Review of the Muskrat Falls and Labrador Island HVdc Link and the Isolated Island Options

Prepared for:
Hon. Jerome Kennedy, Q.C.
The Minister of the Department of Natural Resources
Government of Newfoundland and Labrador

Prepared by:
Manitoba Hydro International Ltd.
211 Commerce Drive
Winnipeg, Manitoba R3P 1A3, Canada
www.mhi.ca

October 26, 2012

Figure 4: Comparative Energy Forecasts - the 2012 Interconnected Island option versus 2010 Load Forecast

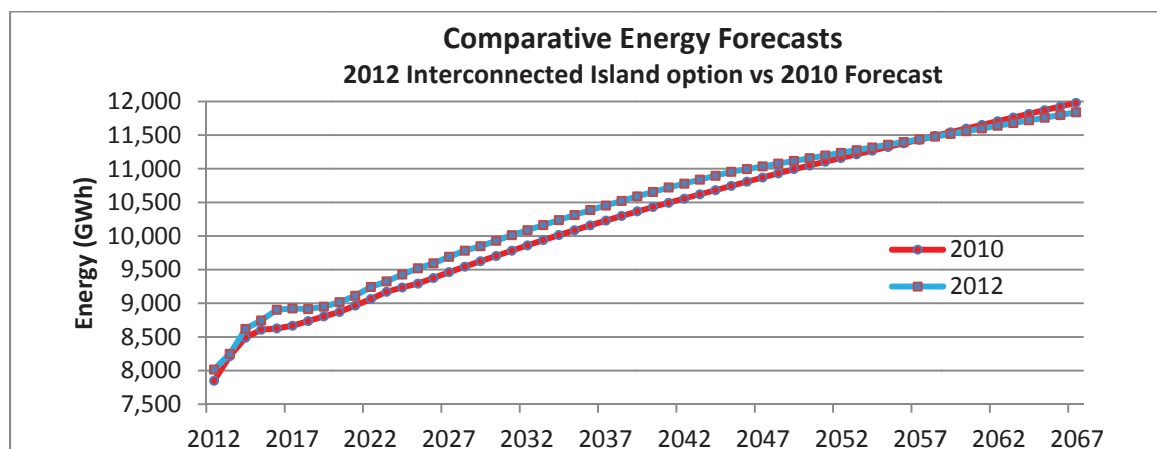
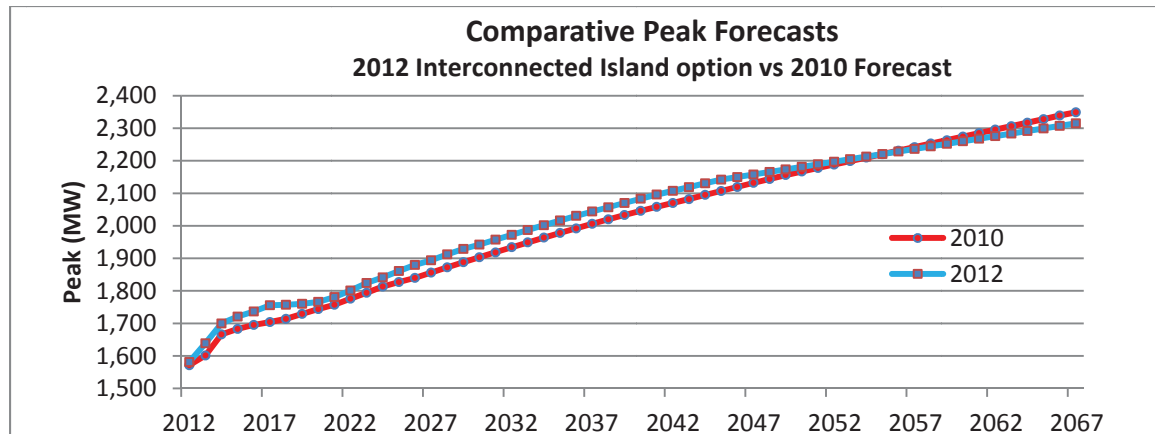
This analysis compares the forecasts prepared in 2010 and 2012 where the 2012 Interconnected Island Load Forecast is being used as the basis for Decision Gate 3. Generally, the 2012 energy and peak forecasts are higher over the 20-year forecast period. The 2012 energy and peak forecasts converge towards 2010 forecast levels over the extrapolation period and cross over around 2057 (see Figure 4 and Figure 5).

Figure 8: Typical HVdc Transmission Guyed Tangent Structures which comprise approximately 85% of the towers in the Labrador-Island HVdc transmission line

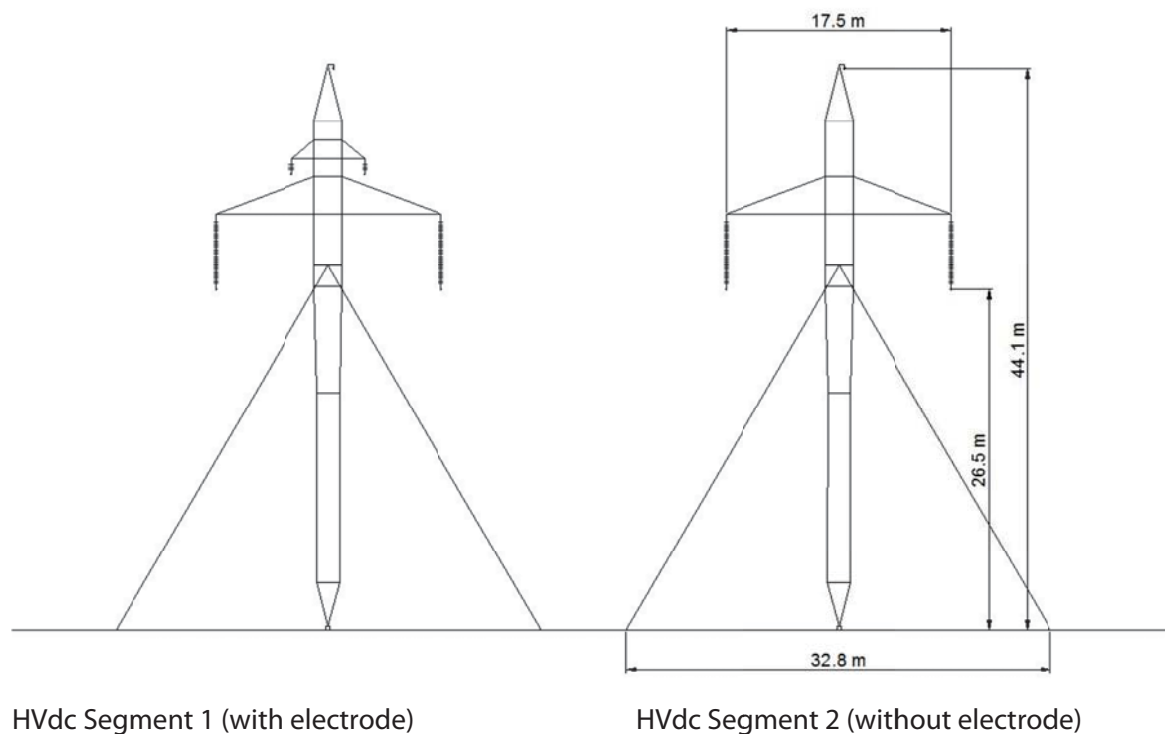
Engineering work is in progress to complete the detailed design for the HVdc line. Nalcor has defined 12 structure families, with a total of 25 structure types, required to economically construct the line. Wherever possible, an effort was made to use common structures in the various loading zones in an effort to minimize the number of unique, custom structures which mitigates design and construction cost.

Nalcor's design controlled the structure loading from the various ice-and-wind loading combinations by reducing or increasing the ruling span in the 11 weather-zone regions. Generally, as the loading increased, the design ruling span and conductor tension was

Figure 9: Climatic Ice Loads along the HVdc Transmission Line Route compared to the CSA Standard 1:500-year return period limit

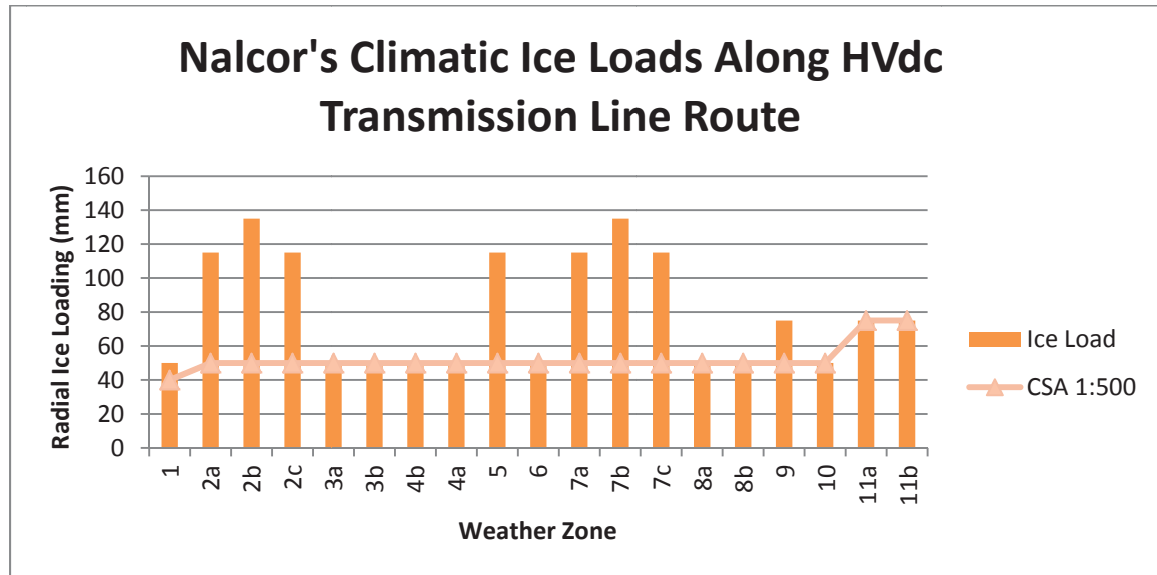
MHI finds Nalcor has completed a thorough assessment of the various climatic regions impacting the ± 350 kV HVdc line from Muskrat Falls to the Soldiers Pond transmission line route. In documents provided by Nalcor to MHI, the meteorological research determined that 11 zones along the route corridor with a number of subzones, each with a unique zone-specific climatic loading is required to reliably predict climatic loading to the transmission line (see Figure 9).

Nalcor's research studies to define the climatic loadings along the transmission line route were based on 50 years of data, as outlined in the document "Muskrat Falls Project – Exhibit 97, Appendix A Revision 1". The climatic loadings for each line section are approximately equivalent to the climatic loadings calculated assuming Canadian Standards Association (CSA) 1:500 year-return period.

MHI notes that CAN/CSA C22.3 suggests a greater reliability of design to 1:150-year or 1:500-year return periods for lines of voltages greater than 230 kV which are deemed of critical importance to the electrical system. It is MHI's opinion the ± 350 kVdc and 315 kV ac lines proposed for the Lower Churchill Project be classified in a critical importance category due to their operating voltage and role in Nalcor's long term strategic plan for its transmission system and be designed to a reliability return period greater than 1:50 years.

Figure 11: Comparative Energy Forecasts – The 2012 Isolated Island option versus 2012 Interconnected Island option

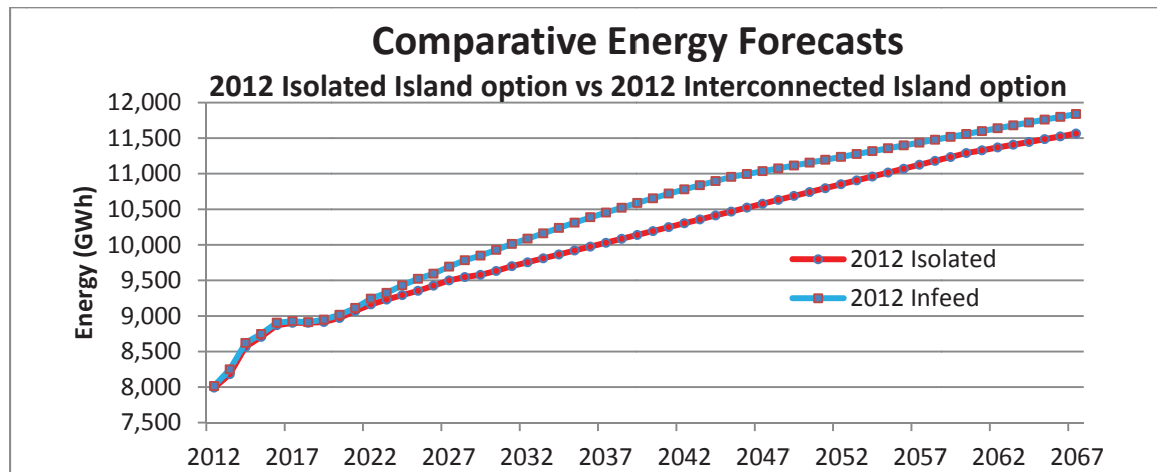
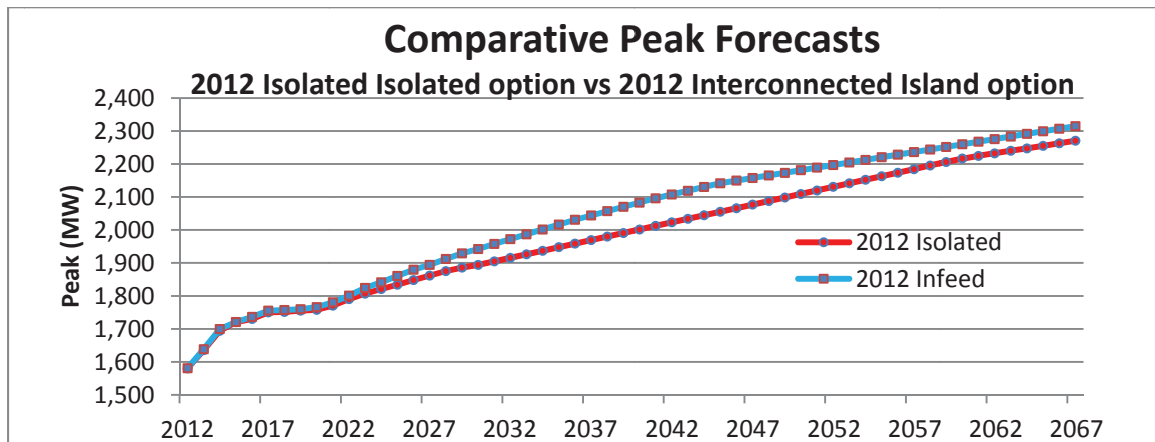
The energy and peak forecasts for the Isolated Island option are lower than the respective forecasts for the Interconnected Island option (see Figure 11 and Figure 12). These differences are maximized by 2045, when the Isolated Island option energy forecast and peak forecast are lower by 487 GWh and 86 MW, respectively. After 2045, the gap narrows so that by 2067, the Isolated Island option energy forecast and peak forecast are lower by 276 GWh and 44 MW, respectively.

Table 8 demonstrates that the energy and peak differences between the two options are minimal in 2012. The main cause for the difference in energy consumption is energy reductions in the domestic sector. The general service and other load reductions are minimal throughout the forecast. There is no difference in the industrial load because both options use the same forecast.
